Informal document **GRSG-128-21**  
128th GRSG, Geneva, 7-11 October 2024  
Provisional agenda item 14

Informal document **GRVA-18-39**  
18th GRVA, Geneva, 22-26 January 2024  
Provisional agenda item 9(b)

# UN Regulations No. 78

## Limitations and Improvements for S-EPAC

Fig. 2. CG positions of motorized vehicle, motor cycle, electric bicycle  
Image sources: Daimler, Yamaha, Merida

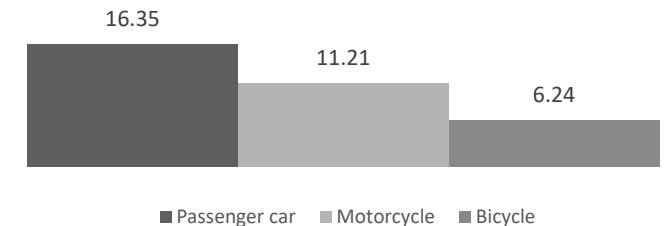
- **Issue:**
  - The center of gravity (CoG) of S-EPACs combined with the level of efficiency of every ABS does not fit to the braking test "Stops on high friction surface" (chapter 9.3) which includes a vehicle independent deceleration threshold of  $6.17\text{m/s}^2$  (cf. slide 2)

- The deceleration threshold of  $6.17\text{m/s}^2$  on high friction surface in UN R78 does not fit for bicycles physics (geometry, center of gravity, etc.)
- A brake efficiency of 100% is impossible in comparison to the rider's best values due to the working principle of ABS
- An ABS efficiency of 80-90% can be rated as very good and leads to a significant increase of stability and hence safety of the bike

- **Proposal:**
  - Changing the deceleration threshold definition from a vehicle independent one to a vehicle dependent one as in braking test "Stops on low friction surface" (chapter 9.4) enables a better fit of UNECE R78 to S-EPACs (cf. slide 3)
